Oakdale Central VMP - Addendum

Prepared for

Goodman Property Services (Aust) Pty Limited

4 December 2012

Drawing No. SKC118 - Detail
(Source AT&L)

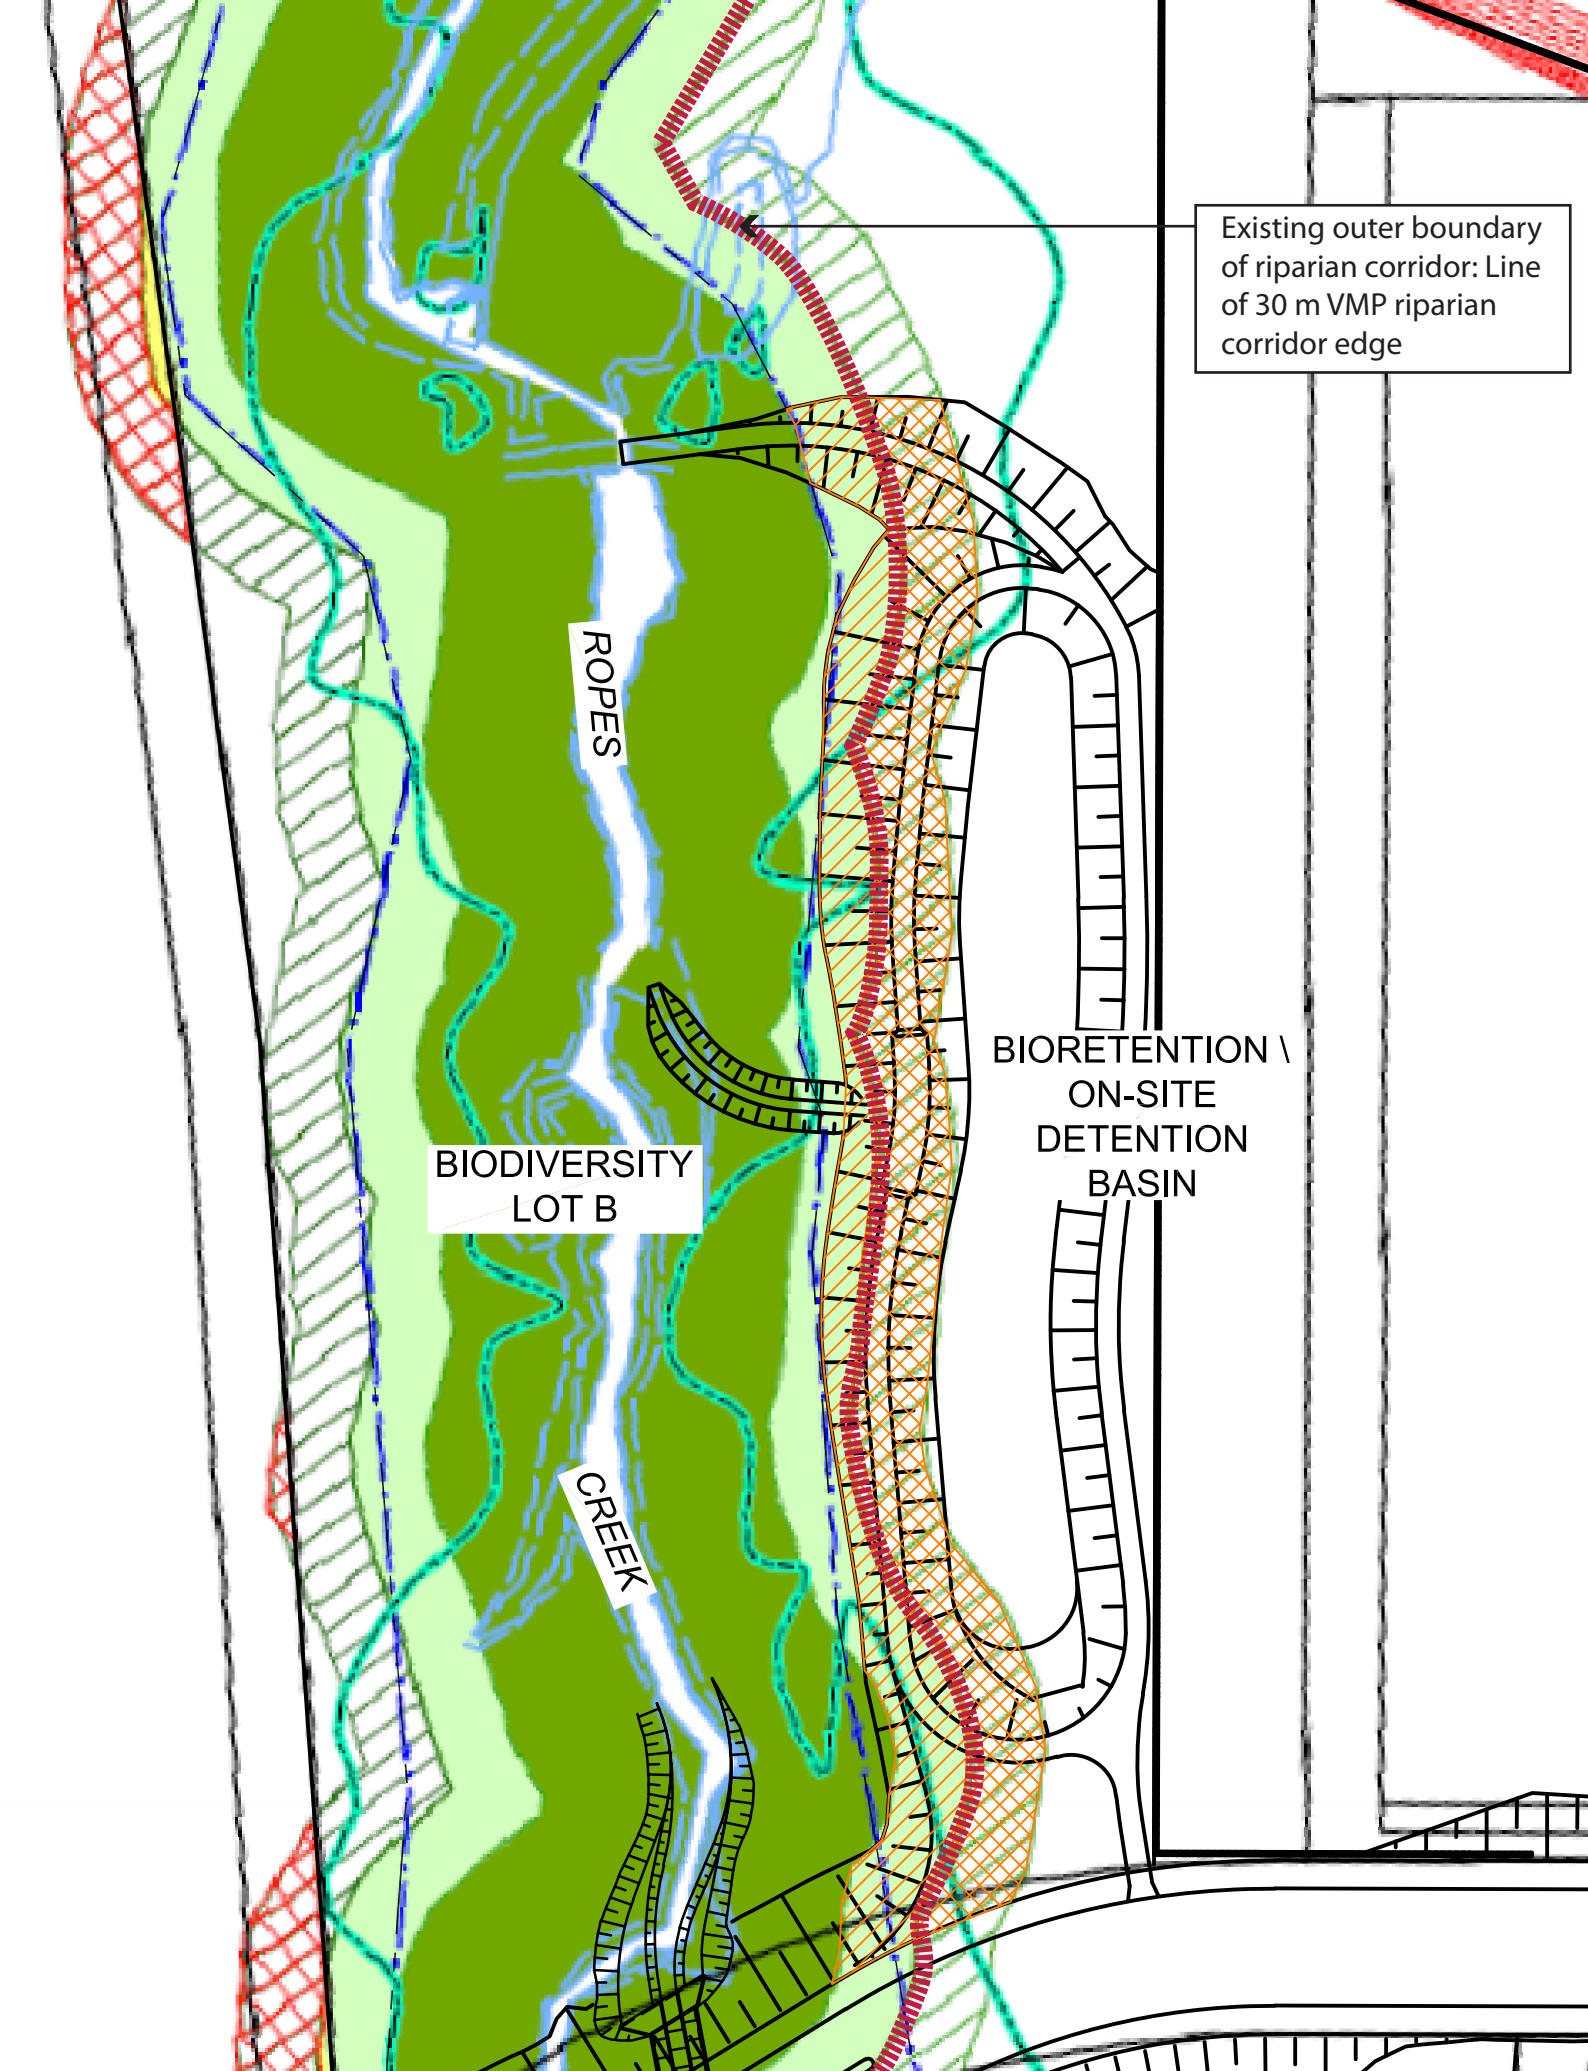
Attachment C shows an annotated detail of Attachment B, focussed on the area of the proposed basin. As can be seen, the existing outer boundary of the ORZ creates a waving line across the face of the basin wall. The riparian corridor planting along this line would abut an exotic grass treatment. This planting / grass edge is not a preferred long-term management boundary for the riparian corridor, as it provides a long edge that is susceptible to weed invasion. Goodman has therefore proposed to locally increase the amount of riparian planting on the basin batter, such that it abuts the maintenance track that runs around the top of the basin. This will create a substantially more weed resistant long-term management edge, and compensate for a small area at the southern end of the basin where the outer ORZ line runs over the basin wall and onto the inner basin batter.

Existing outer boundary of riparian corridor: Line of 30 m VMP riparian corridor edge

Drawing No. Sketch 01

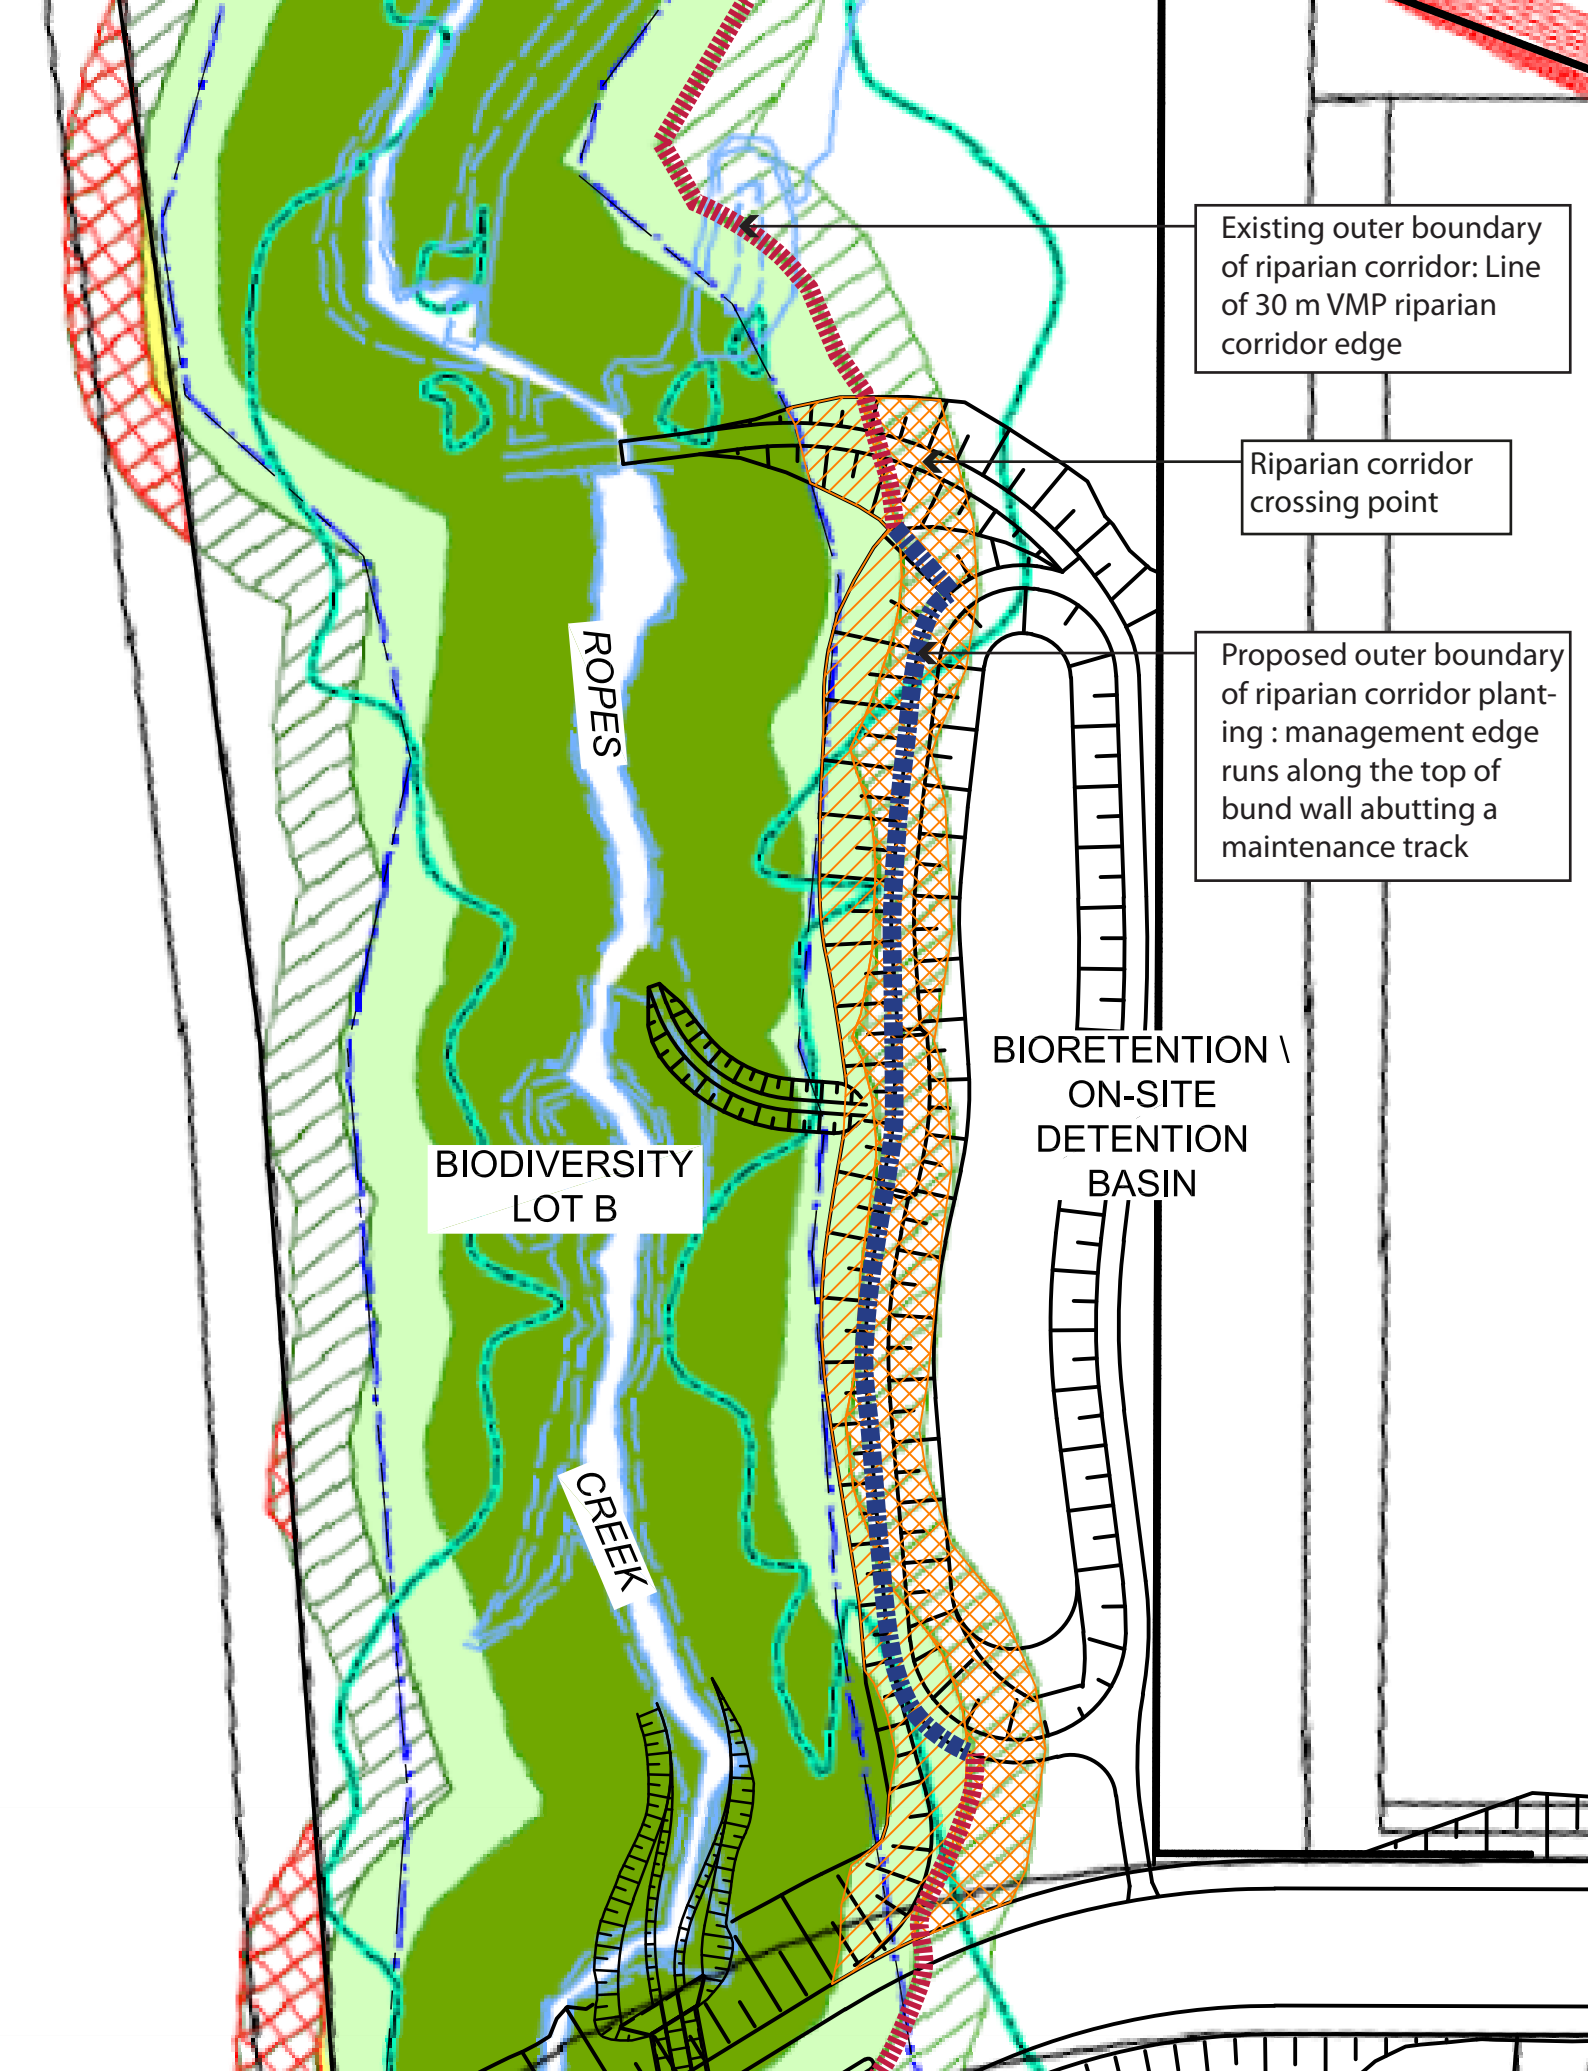
The area of riparian planting to be provided to the basin wall and associated infrastructure as shown in Attachment D, will be treated in accordance with all provisions of the VMP.

Proposed outer boundary
of riparian corridor plant-
ing : management edge
runs along the top of
bund wall abutting a
maintenance track
